CITY OF TEMPE DEVELOPMENT REVIEW COMMISSION

Meeting Date: 03/25/2014

ACTION: Request for a Use Permit to allow gas/fuel sales and a Development Plan Review consisting of a new gas station for FRY'S FUEL CENTER #607, located at 5120 South McClintock Drive. The applicant is Sustainability Engineering Group.

BACKGROUND INFORMATION: FRY'S FUEL CENTER #607 (PL130400) consisting of a new Fry's gas station located at the northeast portion of the site, replacing a portion of existing surface parking. The request includes the following:

ENLARGED SITE PLAN FRY'S 607 NEW FUEL CENTER

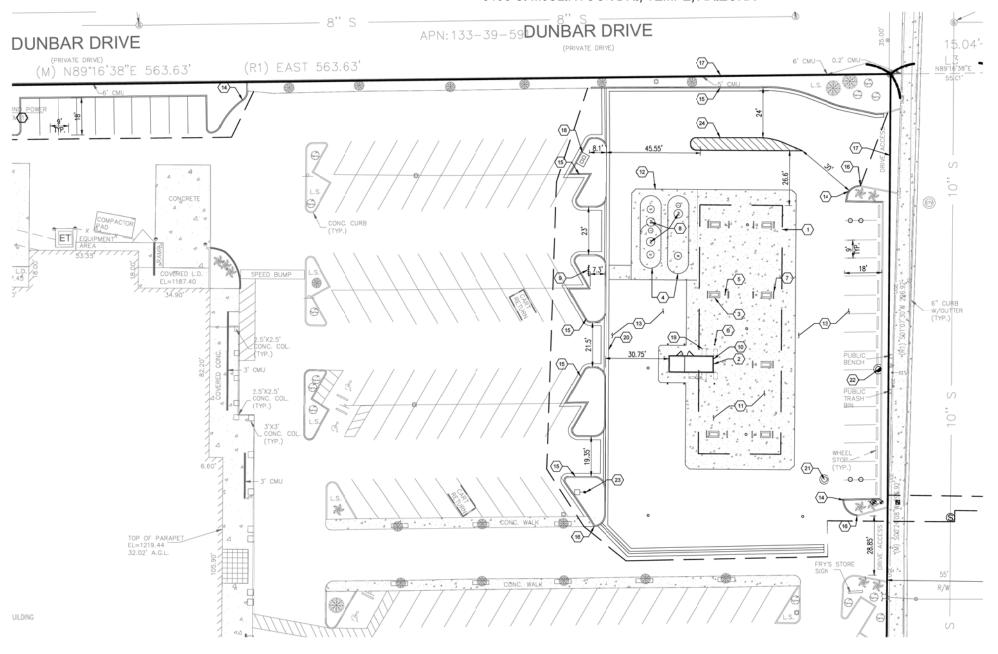
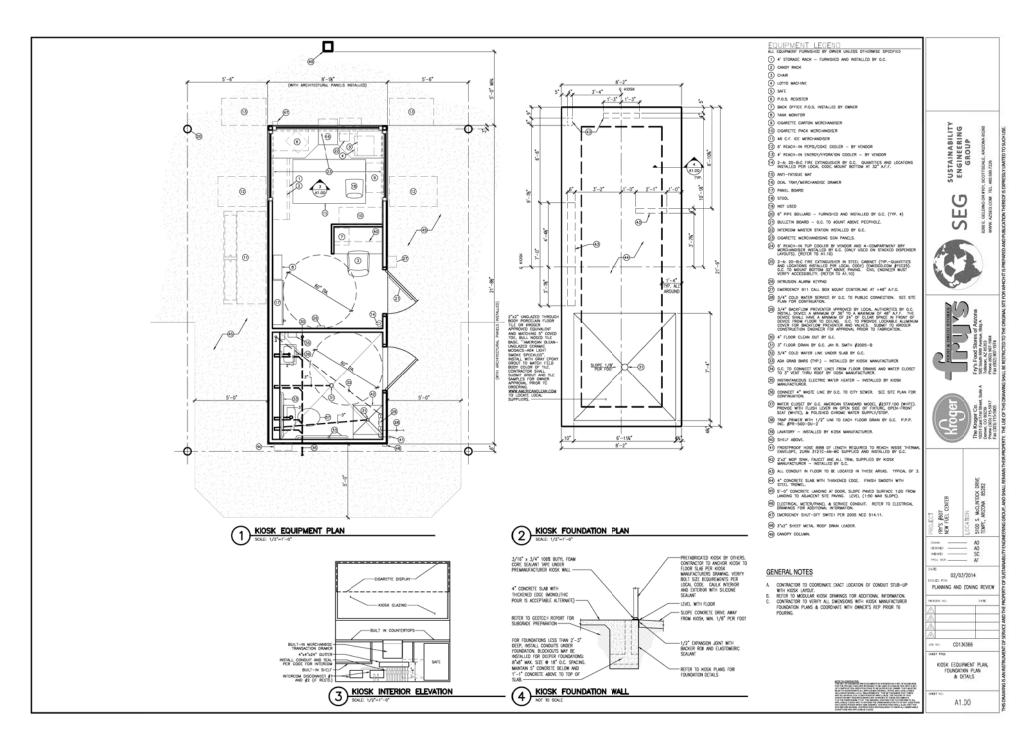
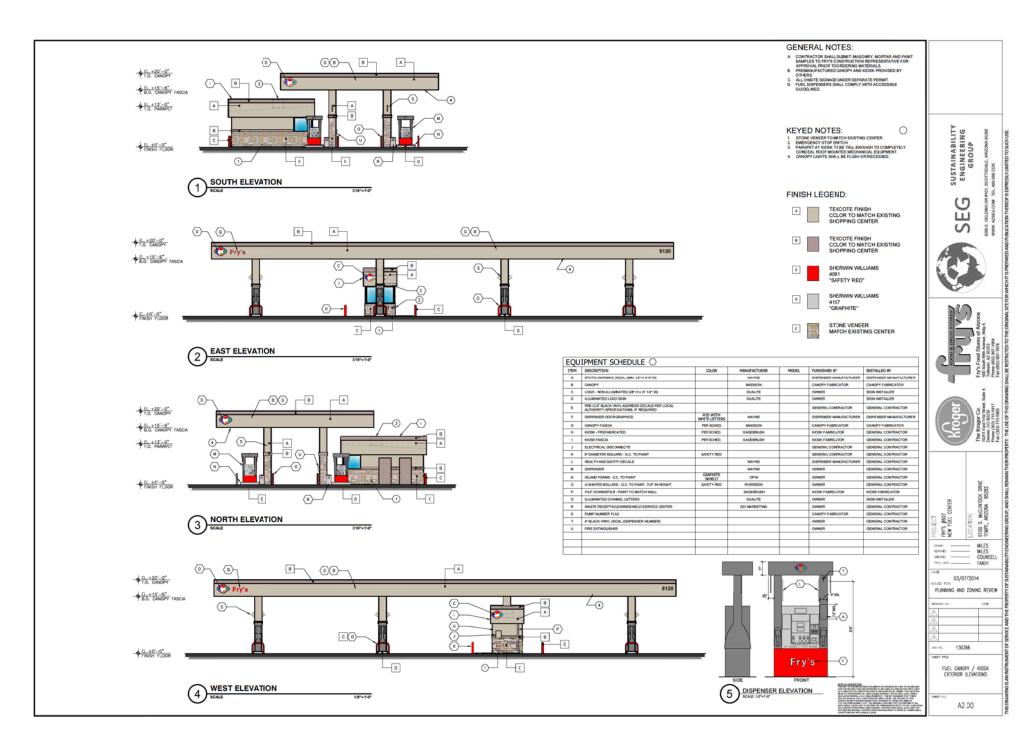
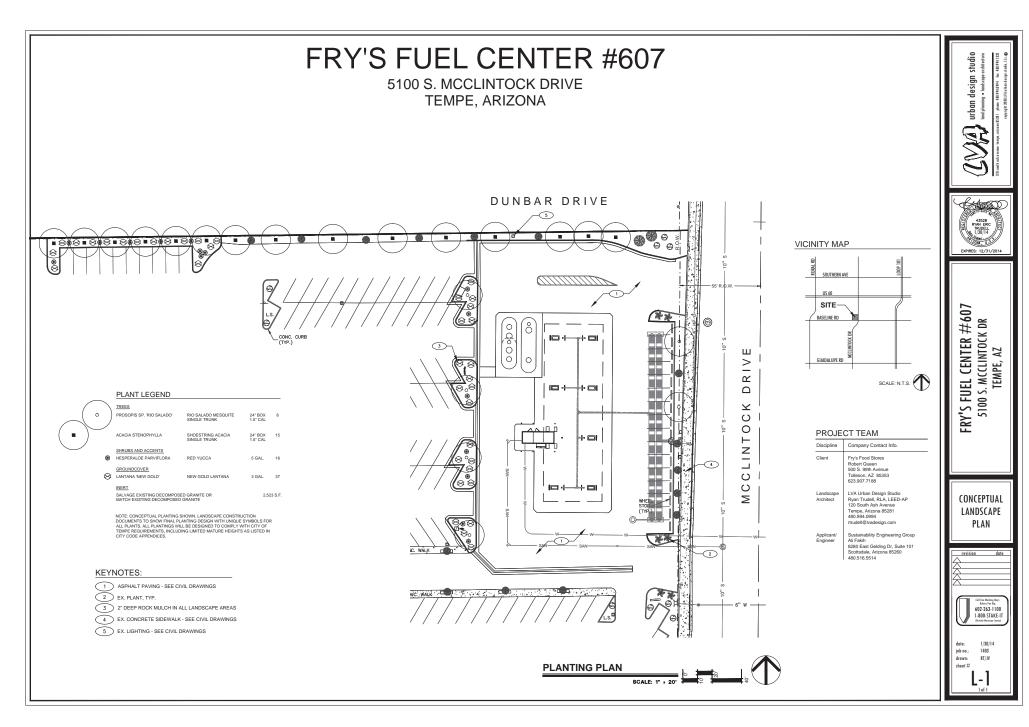
The proposed fuel site improvements are located at the east end of the parking rows. The new gas station will create new break in the angled parking rows. The site plan complements the surrounding parking circulation and will maintain the existing pedestrian path connecting the public sidewalk to the grocery store front.

The site's landscape plan takes into account the new parking end rows along the back side of the gas station. Staff is proposing addition landscape conditions that will provide an enhanced landscape buffer along the northern property edge and existing street front. Other portions of the parking rows will replace dead or missing trees and shrubs. Additionally, not shown on the landscape plan but proposed on the site plan, is an existing parking lot light pole, new tank vent riser and air pump station, in conflict with the required landscape islands provided on the west of the gas station.

- 7. Provide additional Southern Live Oak trees along the northern perimeter of the property, extending from the street front to the new parking row island shown on the submitted plans. Provide spacing of additional oak trees approximately 20 feet on center, except for locations where lighting exists.

- 9. Relocate air station and vent risers out of required landscape islands or extend width of landscape island to accommodate the landscape standards (i.e. minimum 7'-0" wide island, min. 120 sf. in area, with 1 tree and 5 shrubs)

- 10. The result of new parking end islands will require relocation of some existing light poles, to avoid conflict with required trees, providing a minimum 20' separation.
